OCT 29 1975

A. Szukiewicz, Electrical, Instrumentation & Control Systems Branch
THRU: Brian K. Grimes, Chief, Accident Analysis Branch, TR

DAVIS BESSE UNIT NO. 1 MODIFICATION TO THE SPENT FUEL BUILDING ISOLATION AND EMERGENCY

DAY 13 DESSE UNIT #1

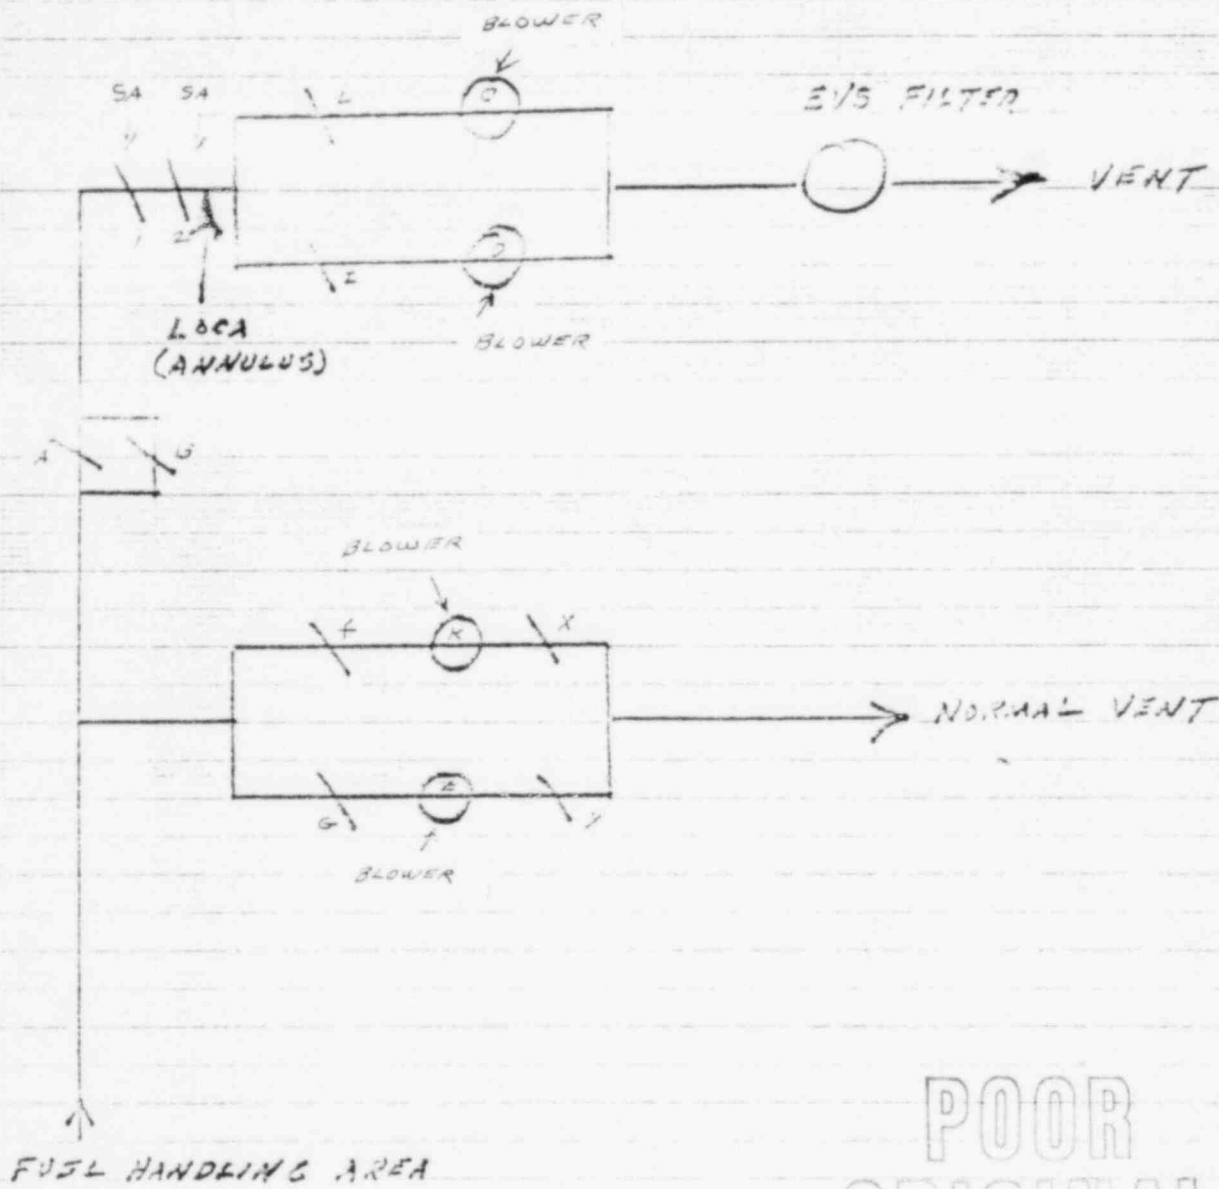
The Accident Analysis Branch requests the assistance of your branch in reviewing the modified design in the Davis Besse Unit No. 1 Spent Fuel Building Emergency Ventilation Filter System which was described to NRC staff by representatives of Bechtel in their meeting with us on October 15, 1975, and in our phone conversation with Ted Quay, of Bechtel, on October 23, 1975. It is our understanding that the proposed modification will be submitted by the applicant in a later amendment to the FSAR. The basic schematic diagram of the proposed revision is indicated on the attached sketch. The ductwork up to the safety grade charcoal filter train is not seismically designed. (We have accepted this on other OL's but require seismic design on current CP applications.) Two dampers in parallel will be located upstream from the outlet to the normal dual train ventilation system. On each of the normal ventilation system train dampers will be located on each side of the blowers. Dampers 1 and 2 on the emergency filter train will fail open on loss of power. (We recognize that a spurious signal causing closure could not be coped with by this design.) The radiation detector all the way down to the actuators should be designed to IEEE-279 (1971) with the exception of the dampers which may be shown by analysis to meet this requirement. Dampers A and B should meet IEEE-279 with exception of seismic design.

This revised design is acceptable for Davis Besse Unit No. 1 only and not for Units 2 and 3. This was emphasized by NRC staff to Bechtel representatives during both the meeting and the phone conversation. We conclude that the proposed revision is a significant improvement over the system currently in the FSAR and that while it does not meet all current seismic and safety criteria, it is acceptable for this plant given the current status of plant construction.
